Re: APPROVAL OF PETITION FROM BISHOP'S HILL, LLC. – REQUESTING PLANNED DEVELOPMENT DISTRICT ON PARCELS AL-56-2 1921 RIVERSIDE DRIVE

Preliminary PDD Review – Staff Comments

Site: 1921 Riverside Drive (Parcel AL-56-2)
Developer: Bishop's Hill, LLC.
Attn. Keith Garot

PDD Layout

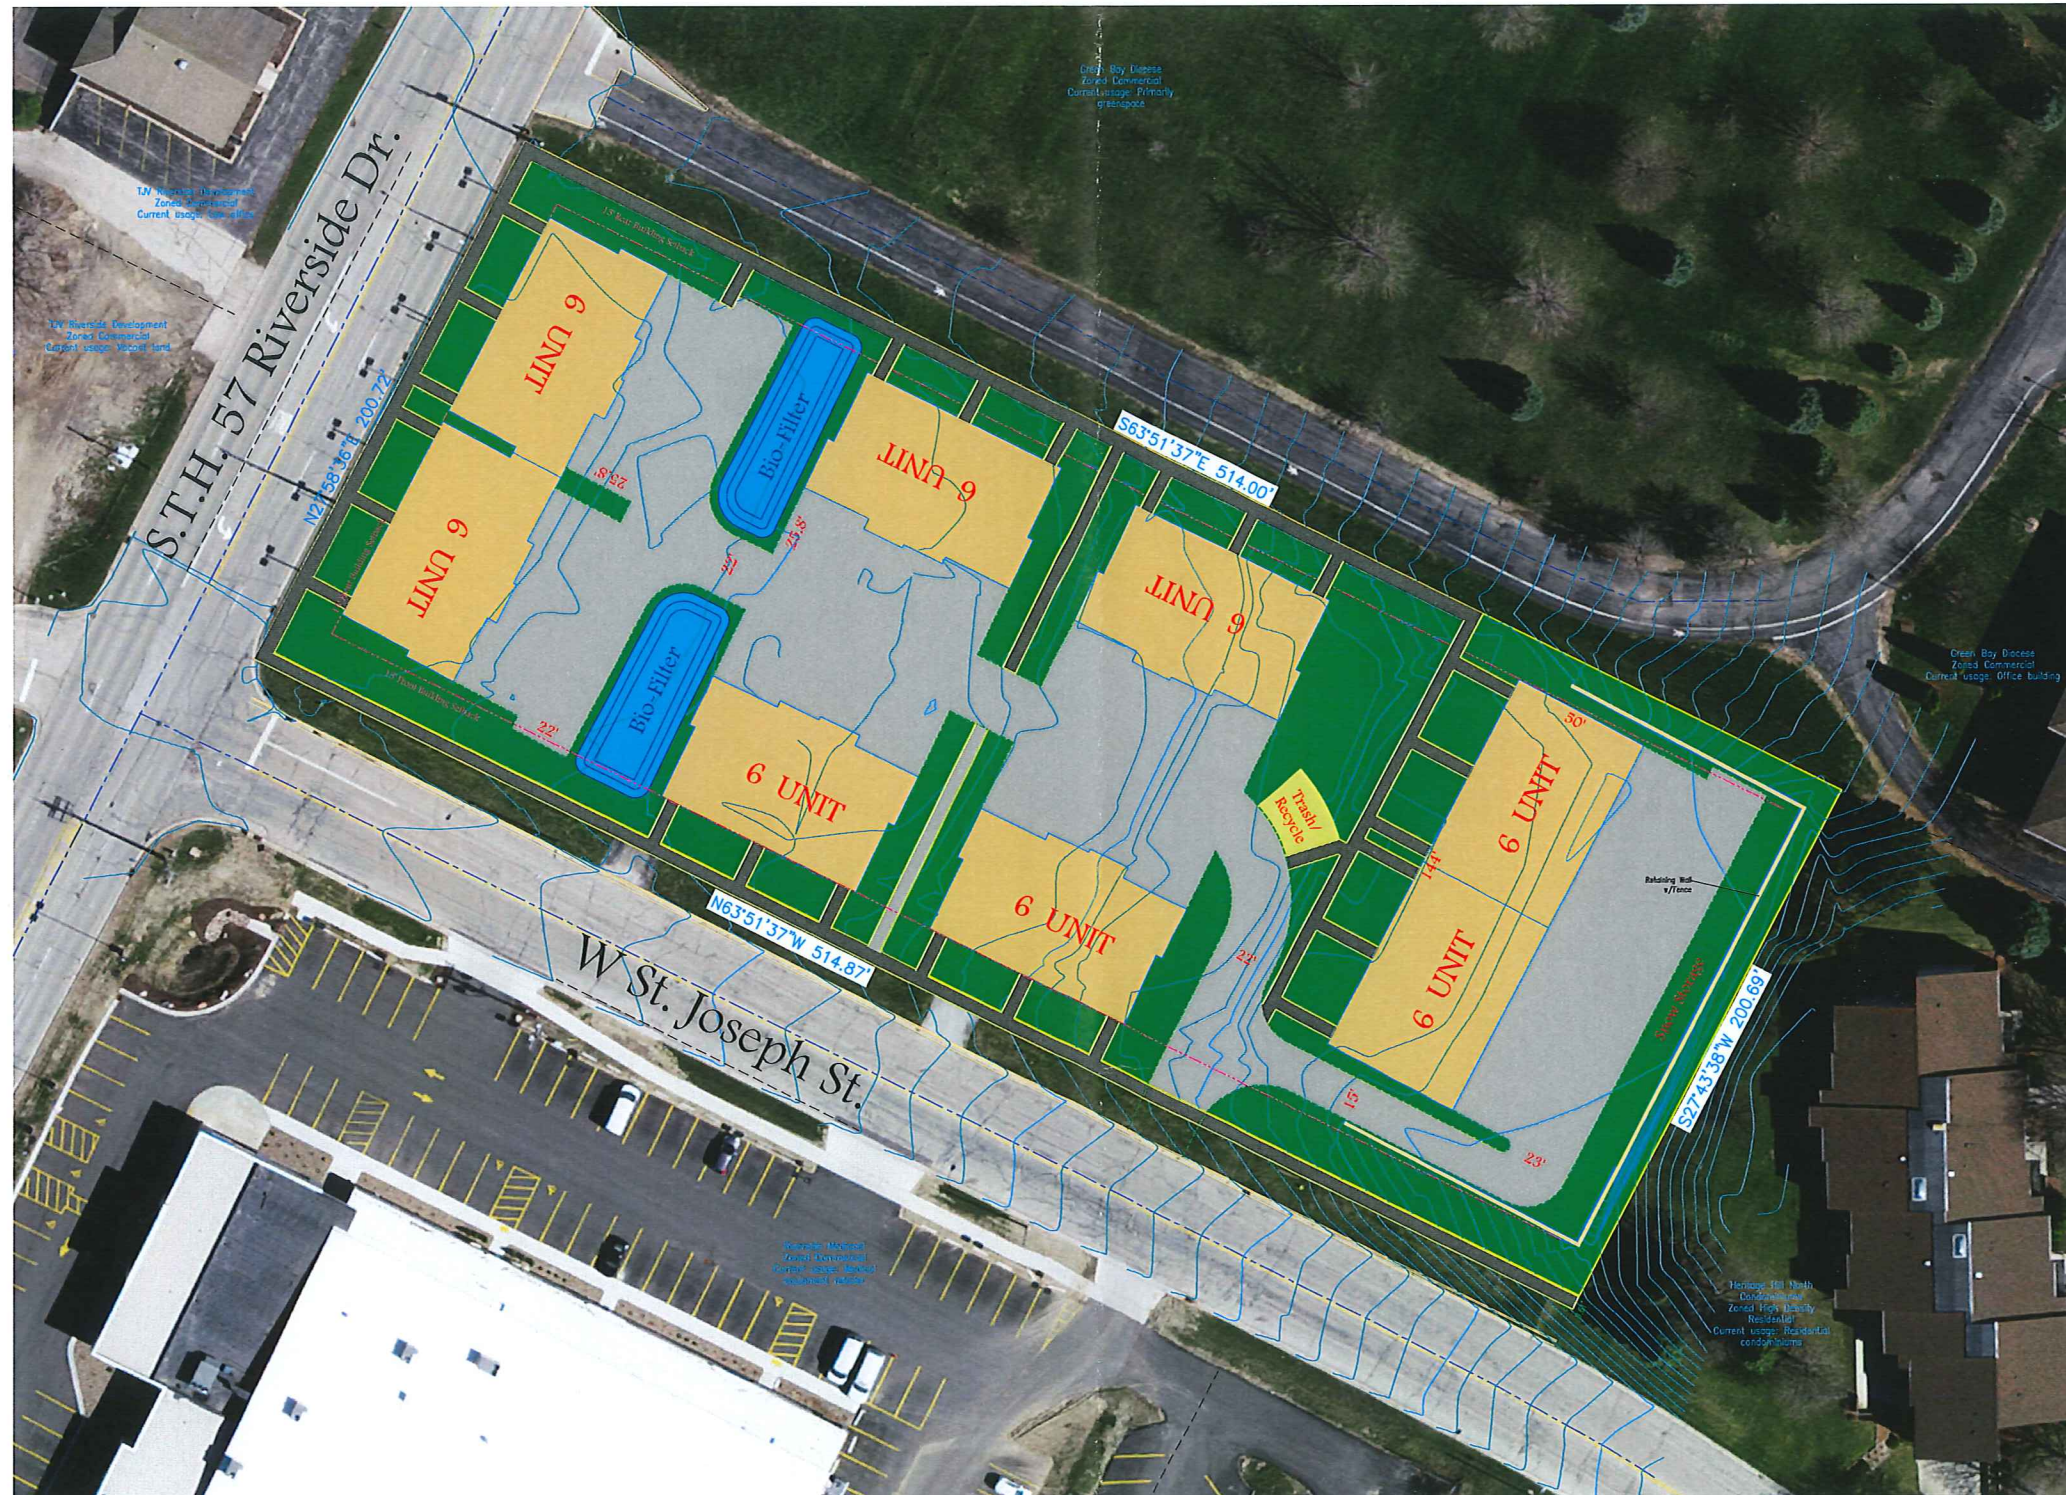
- The use is an allowed and existing use in the surrounding properties.
 - The setback is closer than what is allowed in the appropriate zoning district for the proposed use, but smaller setbacks are called for in the Comprehensive Plan.

- The massing of the buildings is broken up by architectural variations in the building.
 - Pedestrian access to the buildings is provided.
 - Green space and parking is adequate.

- Items to keep in mind for final approval:
 - Vinyl siding is proposed. Vinyl can be considered, but should be a thick grade, in the range of 0.045-0.055.

- The trash enclosure should be screened using the same masonry materials used in primary structures.
 - Landscaped islands should be provided where practical to break-up the expanse of asphalt.

- Public Works Department review:
 - Concerns for the preliminary approval:
 - Traffic plan should be discussed (e.g. access, traffic volumes, any DOT limitations if applicable).

- The size and placement of existing site utilities are limited and may not be useable in current state.
- A grading plan, a utilities plan for service to the site, an erosion control plan, and a post-construction stormwater management plan—all of which must be in an approvable form – will need to be provided. Note that the utilities will be a somewhat complex design, as will the stormwater plan because of the Fox River TMDL.
- If a secondary ingress/egress is provided, as noted in the Fire Department comments, it should be setback a minimum of 60' from the intersection.
